AGENDA
PLANNING AND ZONING COMMISSION WORK SESSION
City Hall, 385 South Goliad, Rockwall, Texas
Council Chambers
February 26, 2019
6:00 P.M.

Project Plan Review History

Project Number	Z2019-003	Owner	ROCKWALL, I S D	Applied	2/15/2019	LM
Project Name	901 W. Yellowjacket Ln.	Applicant	SET ENGINEERS	Approved		
Type	ZONING			Closed		
Subtype	SUP			Expired		
Status	Staff Review			Status

HS11 of 12

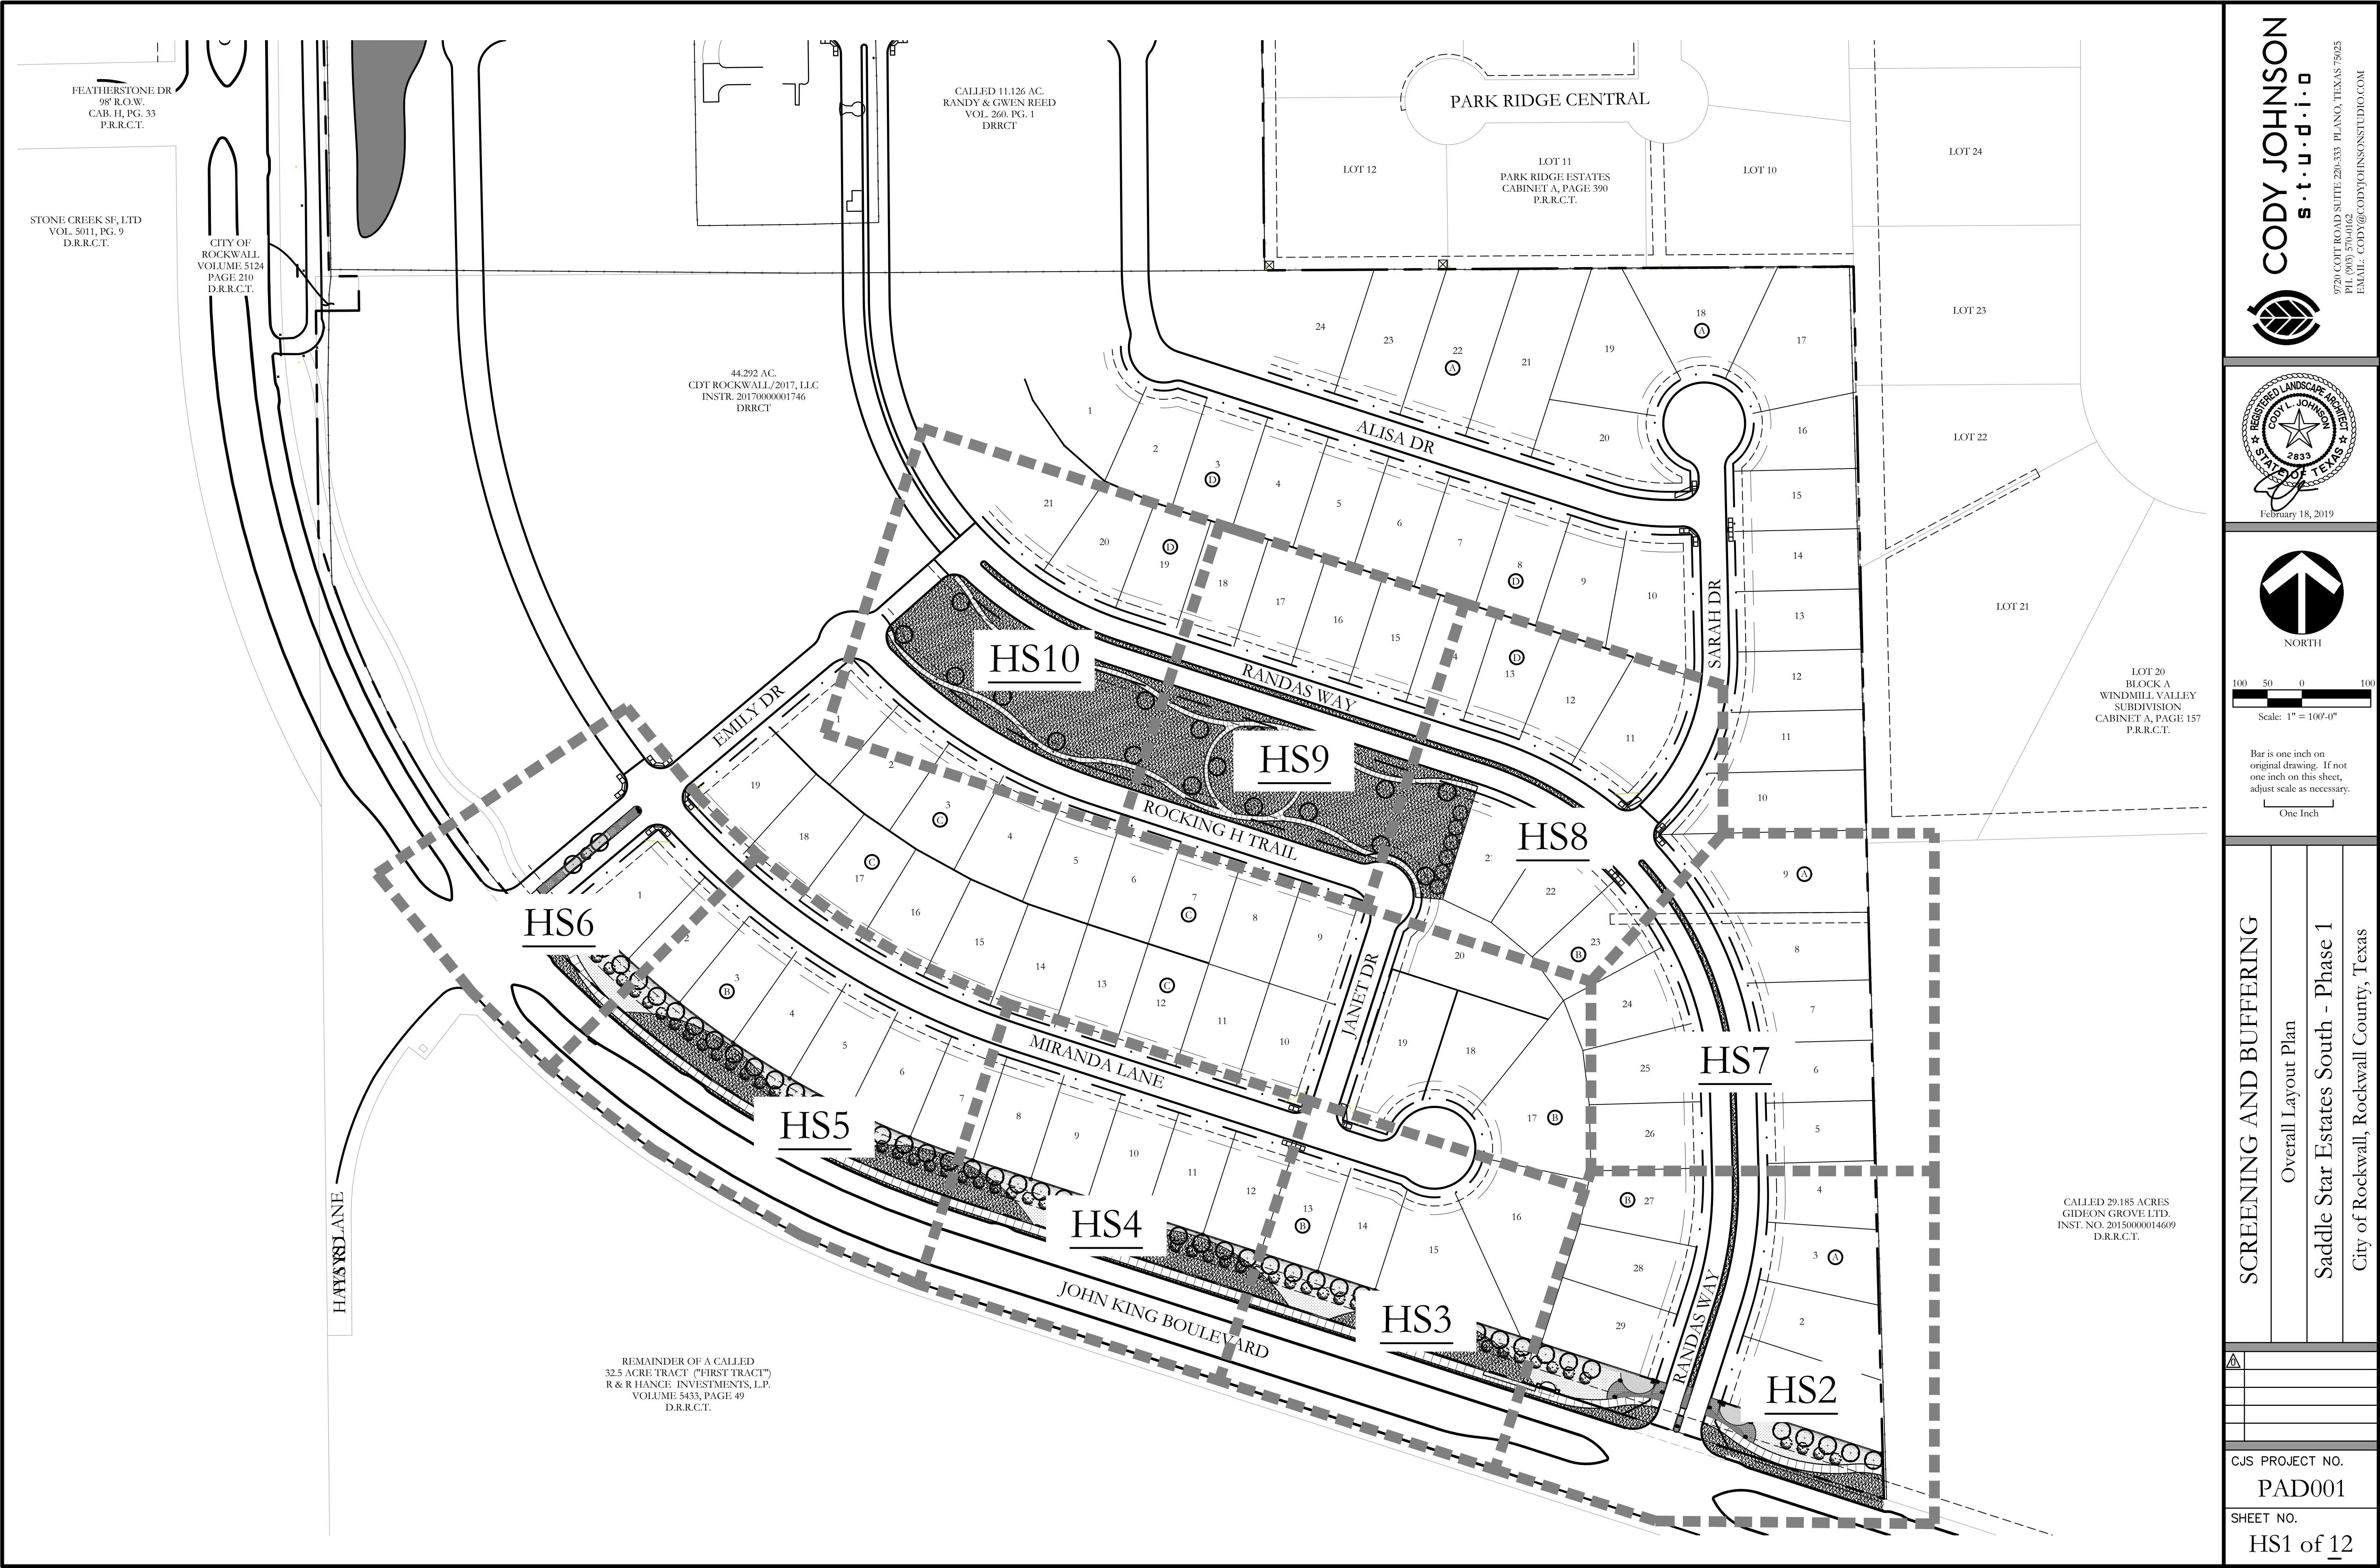
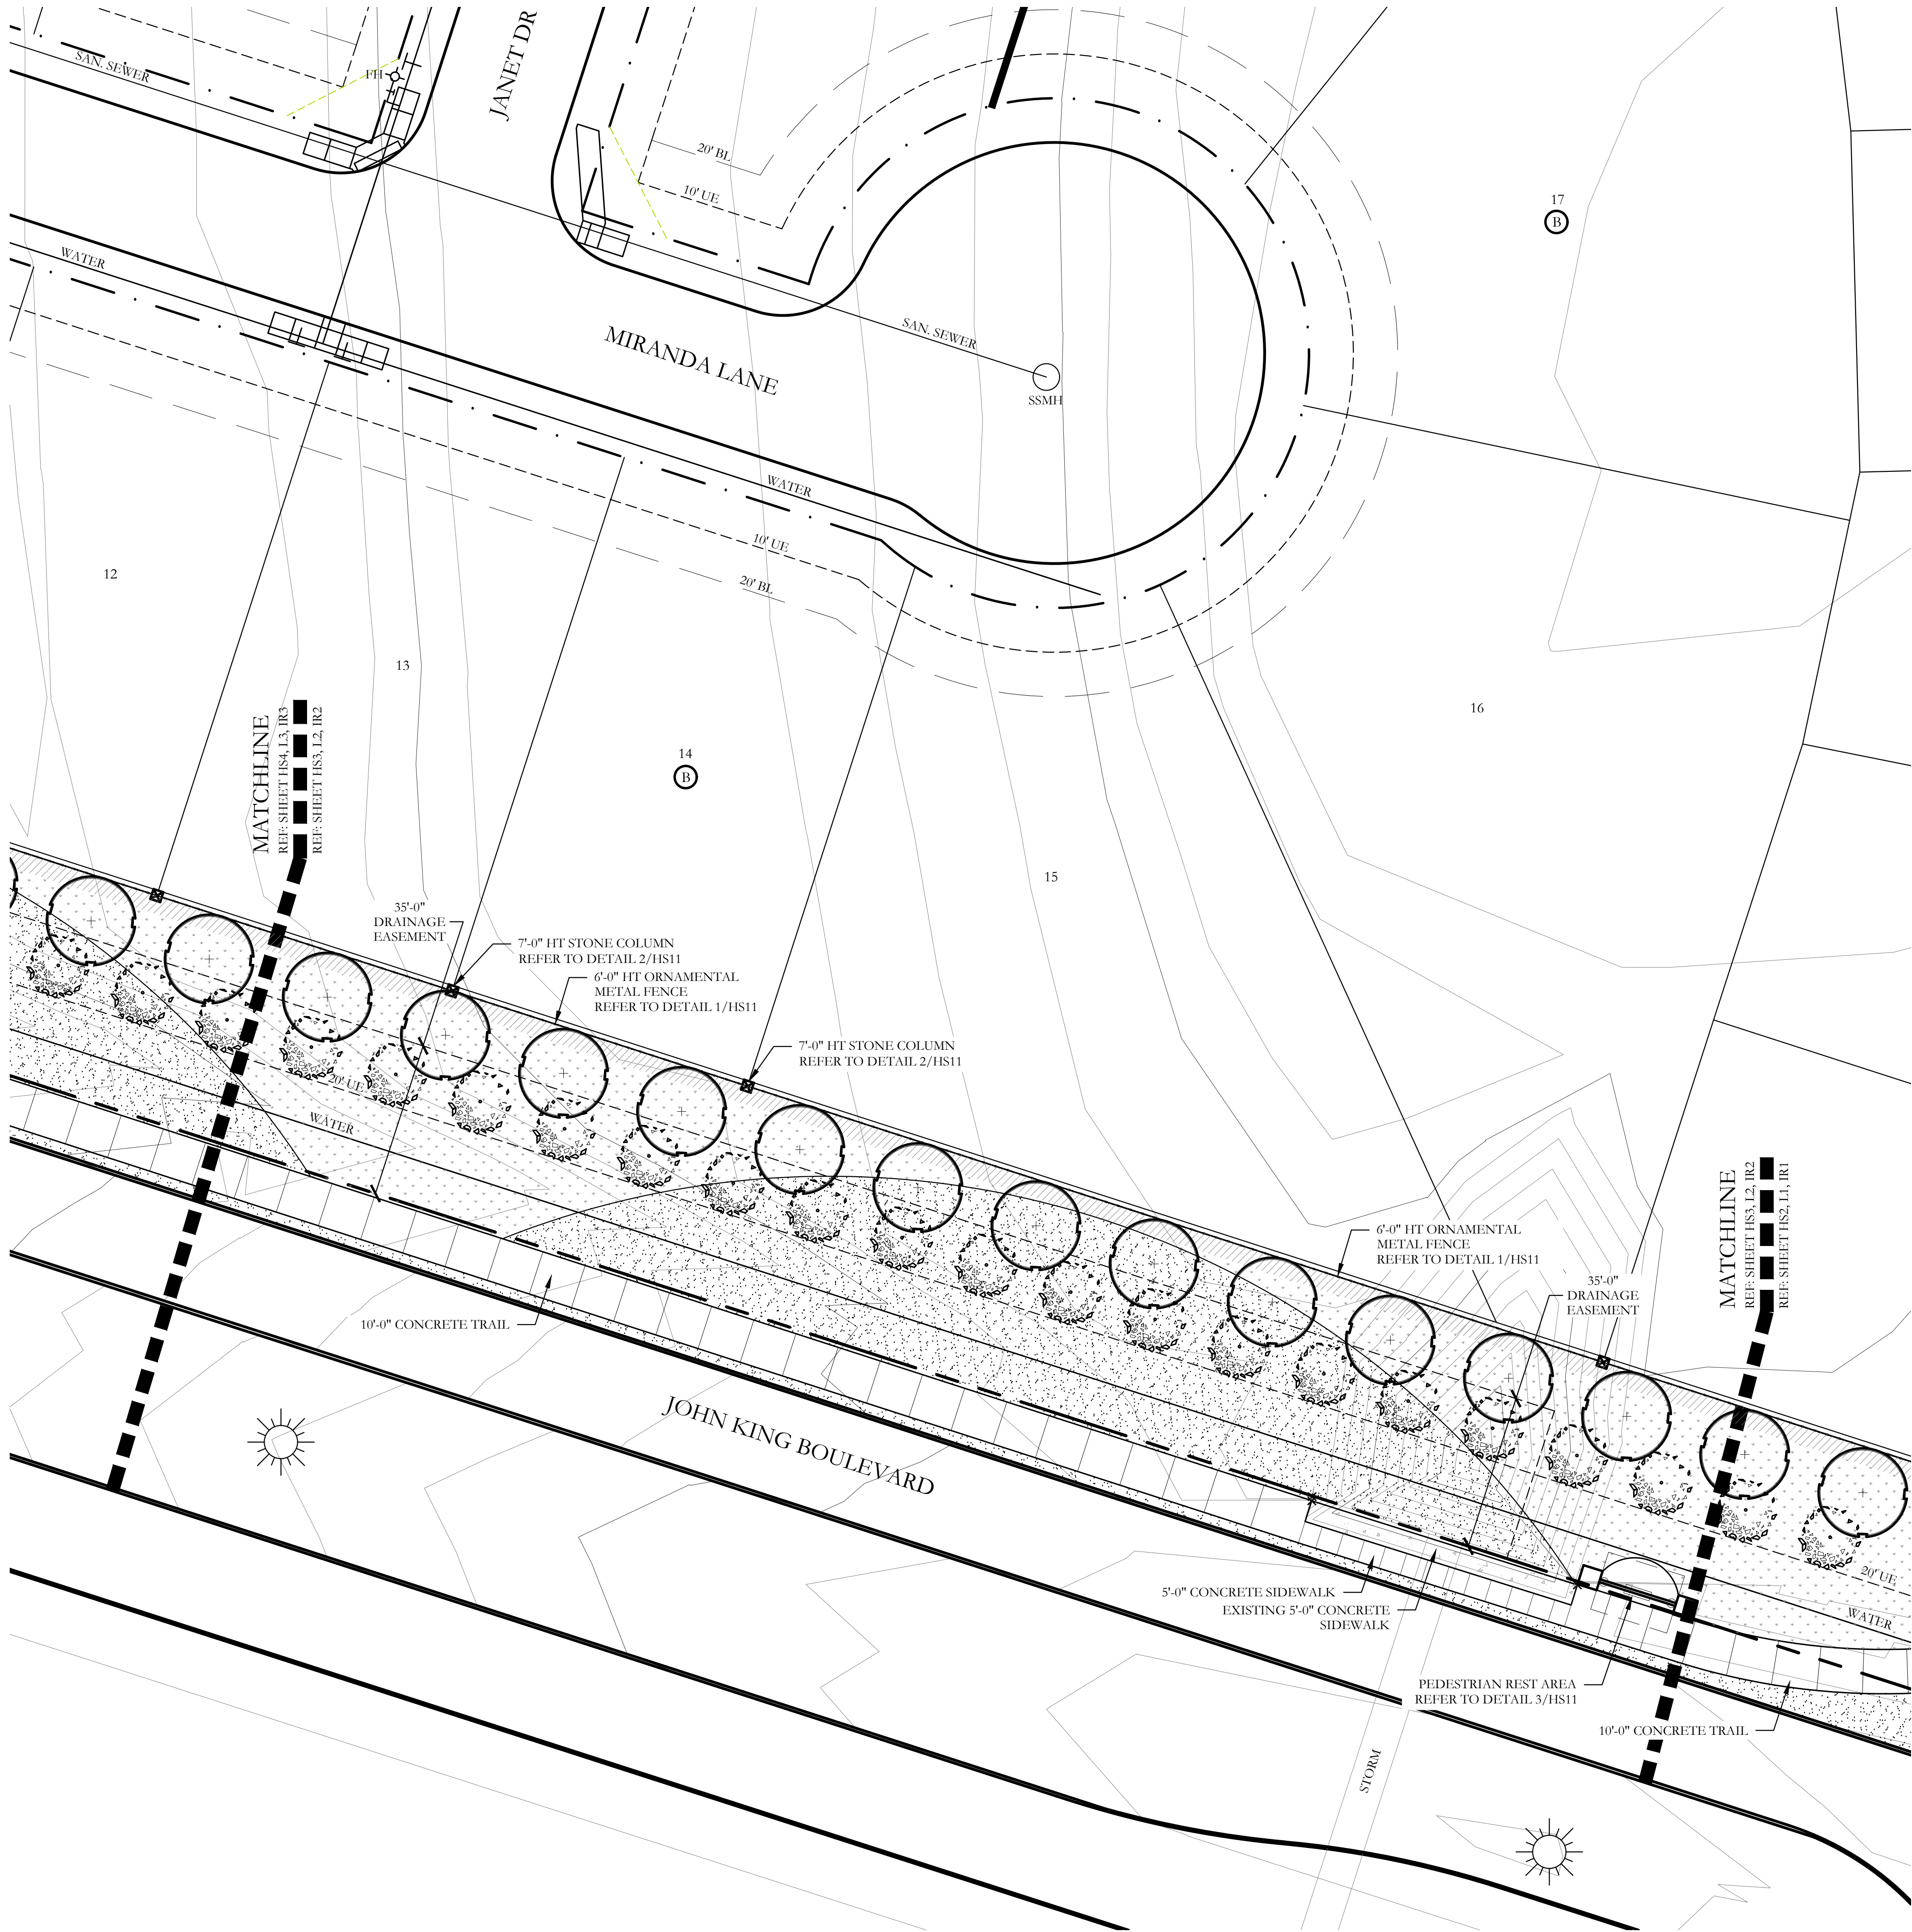
Type of Review / Notes	Contact	Sent	Due	Received	Elapsed	Status	Remarks
BUILDING	Russell McDowell	2/19/2019	2/26/2019				
ENGINEERING (2/22/2019 9:48 AM SH) Sheet HS12 - Add a note stating, "No trees within 5' of utilities." Show Emily Dr to have 65' ROW from John King to Miranda Ln.	Sarah Hager	2/19/2019	2/26/2019	2/22/2019	3	COMMENTS	See comments
FIRE (2/21/2019 5:53 PM AA) Fire lanes width will be measured face of curb to face of curb (FC-FC) and shall have a minimum width of 24 feet. To approve the use of the median, you must provide autoTURN details that exhibits the ability of the largest fire apparatus to navigate the turns into and out of the development in all directions. Contact the Fire Marshal for additional details. Dead-end fire lanes in excess of 150-feet shall be provided with an approved turnaround. Size, type and location of turnarounds are required to be approved by the Fire Marshal. Provide details on how dead-ends will be addressed during the phasing plan. Fire hydrants shall be so spaced such that all portions of the exterior of the building are within 600-feet as the hose lays. Fire hydrants shall be located at every street intersection. Fire hydrants shall be located 6 feet behind the edge of the pavement. Unless otherwise specifically approved.	Ariana Hargrove	2/19/2019	2/26/2019	2/21/2019	2	COMMENTS	comments
